FREDERICK COUNTY PLANNING COMMISSION

TITLE: Mount Saint Mary's Welcome Center
at The National Shrine Grotto of
Lourdes

FILE NUMBER: SP 84-22 (AP #11850, APFO #11851
& FRO #11852)

REQUEST: Site Plan
The applicant is proposing to construct a 7,249 square
foot Welcome/Visitor's Center building.

Exhibit #1 Overall Site Plan: Mt. St Mary's Welcome Center

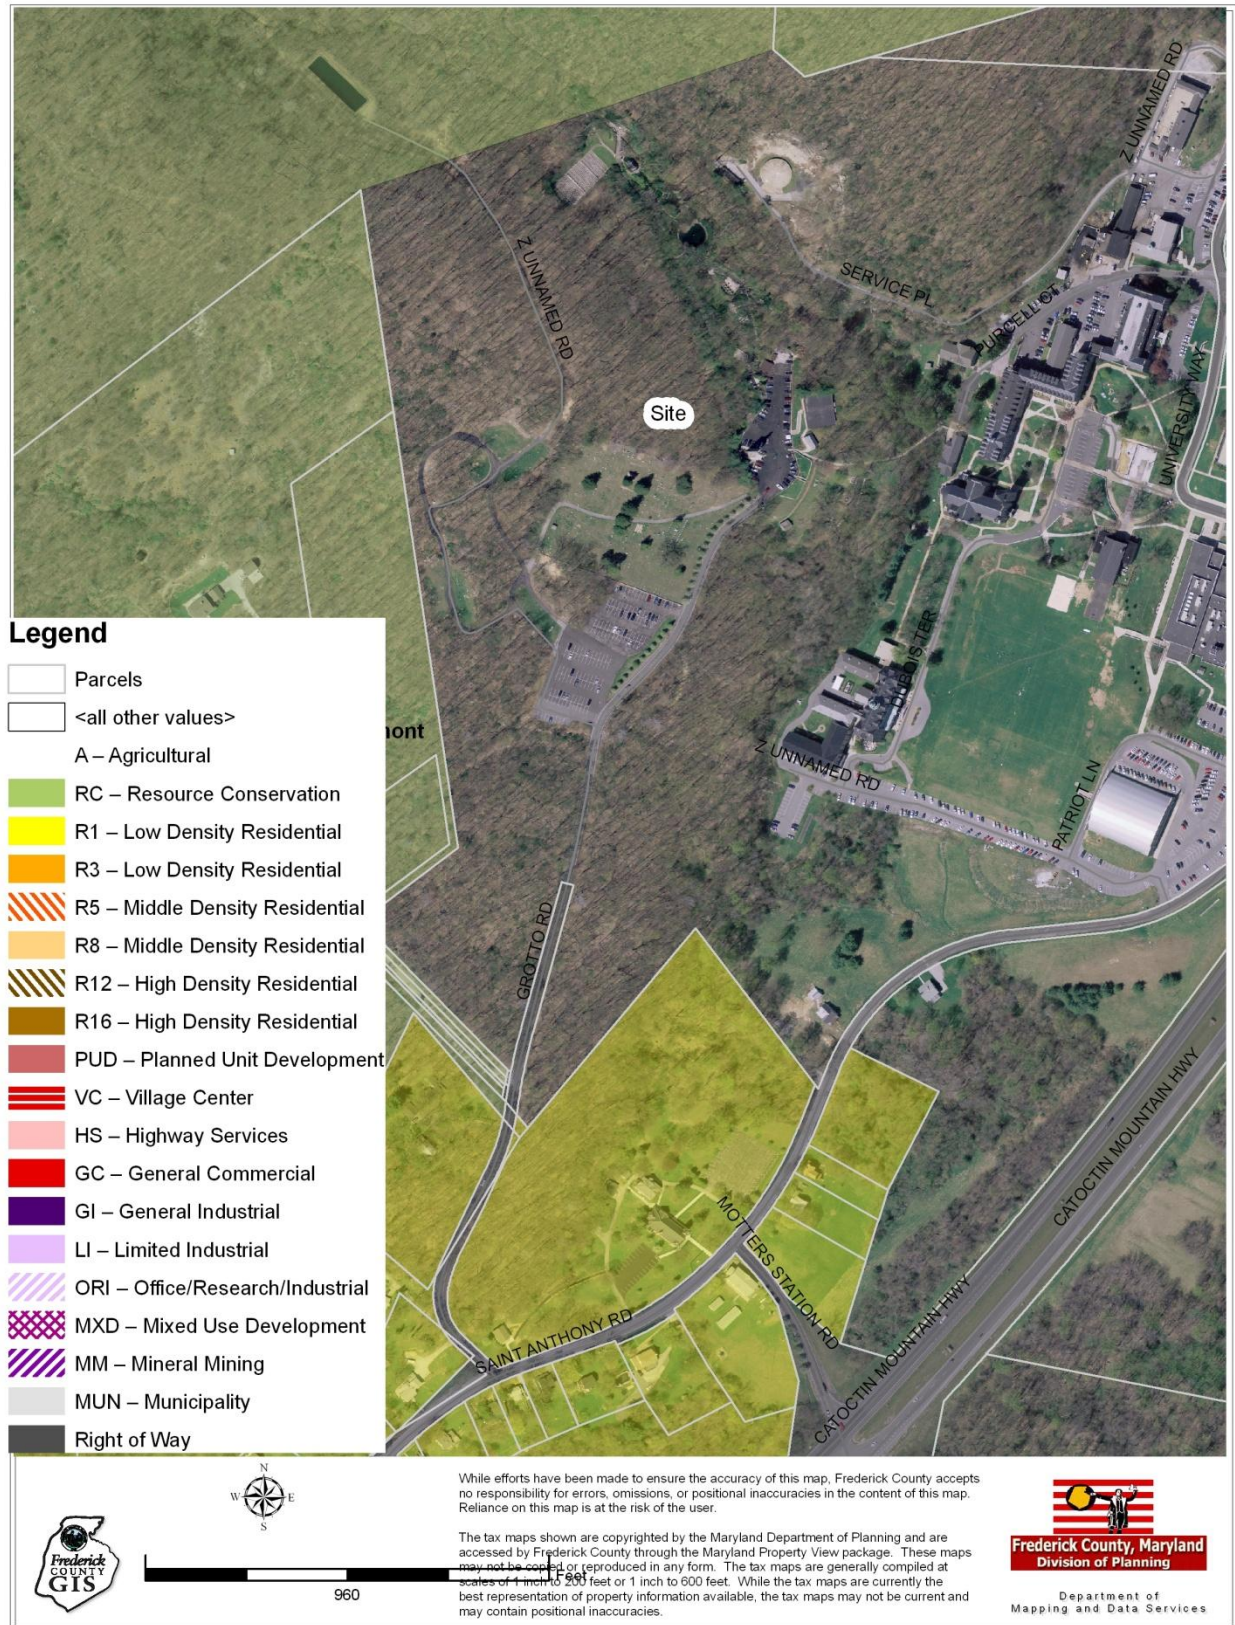
Dimensional Requirements/Bulk Standards: Section 1-19-6.100 of the Zoning Ordinance stipulates the setback requirements and the minimum lot area for the proposed use. The setback requirements are 40-foot front yard and 50-foot rear yard, with 50-foot side yards. The maximum height allowed is 30 feet; the Applicant is proposing 37.3 feet. The minimum lot size for the zoning district is 5 acres.

Per Section 1-19-6.160 of the Zoning Ordinance, additional height can be allowed if for each 3 feet of increased height of the structure, the required side and rear yard setbacks are increased by an additional foot. Therefore, the proposed height increase to 37.3 feet requires an additional 2.4 feet of side and rear yard setback. The Applicant has provided the additional setback area proportionate to the proposed height increase.

Access/Circulation: The access will be via the existing Grotto Road, which is located to the north of St. Anthony Rd. The Applicant is proposing a traffic circle that serves as the entryway into the Visitor's Center and the adjacent parking areas.

Parking: Pursuant to §1-19-6.22 of the Zoning Ordinance, 1 parking space is required for every 400 square feet of floor area. Therefore, 7,249 square feet of floor area requires 18 spaces. The Applicant is providing parking via an existing 26 space lot to the north of the proposed Visitor Center, as well as a 150 space lot to the south, including 2 ADA accessible spaces.

Loading Area: The Applicant has requested a loading space modification in accordance with Zoning Ordinance Section 1-19-6.210.D. The Applicant does not have the need for any loading spaces associated with this site and use. Staff supports granting this modification request.

Landscaping: The Applicant is requesting a modification from the Landscaping Ordinance Section 1-19-6.400.A.2.c, in order to provide an alternate planning design to the Planning Commission. Staff supports this modification request.

Lighting: The Applicant is providing lighting by building mounted lights only. The Applicant has noted on the plan that lighting will not exceed 0.5 ft/candles at the periphery of the site and lighting will be directional onto the site through the use of shielding and lighting orientation.

1. Site plan approval for a period of three years from today's date.
2. Approval of Zoning Ordinance Modification requests for the following code sections:
 - a. §1-19-6.400.I Alternate Landscape Requirements
 - b. §1-19-6.210.D Loading Space Modification

1. Address all agency comments as the plan proceeds through completion.
2. Note approval of Zoning Ordinance Modification requests for the following code sections on the site plan:
 - a. §1-19-6.400.I Alternate Landscape Requirements
 - b. §1-19-6.210.D Loading Space Modification
